**REMARKS**

This Amendment is in response to the Office Action of June 1, 2005 in which the Examiner made certain technical objections to the claims and drawings. The Examiner also rejected claims 1, 2 and 16 as being unpatentable over Davies U.S. Patent No. 2,839,660.

Serial No.: 10/510,496  
Docket No.: 66434-015

**Amendment to the Drawings:**

FIG. 5

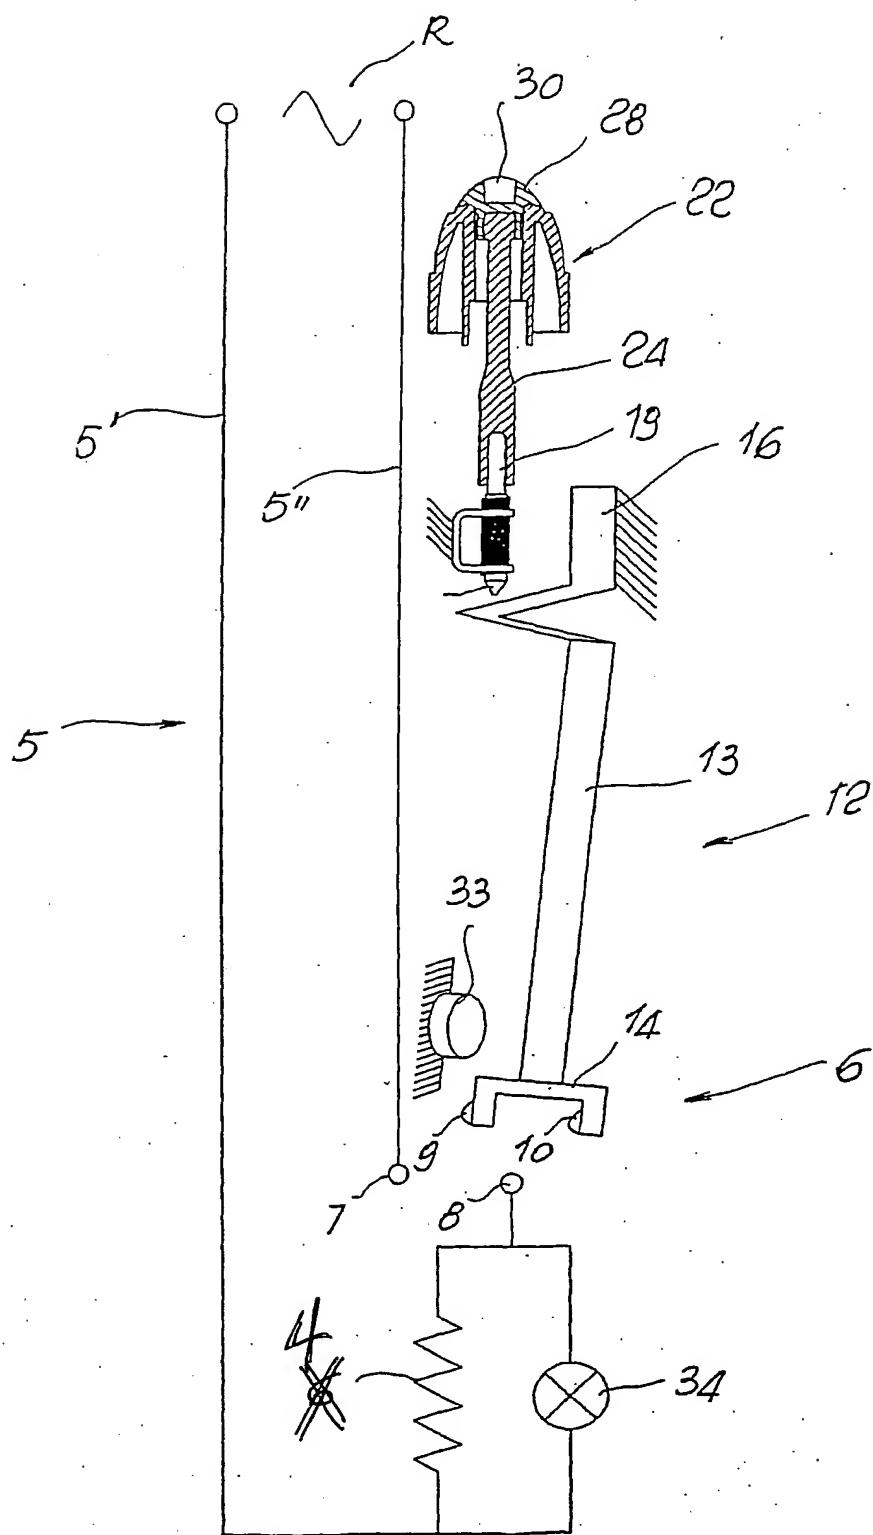
With respect to the technical objections, the drawings have been amended in order to change reference numeral 6 (shown connected to the resistance element in Fig. 5) to reference numeral 4. This eliminates the duplication asserted by the Examiner, and identifies the electrical resistance which is claimed. No new matter has been introduced.

Figure 5 – change reference number 6 for the resistance to 4
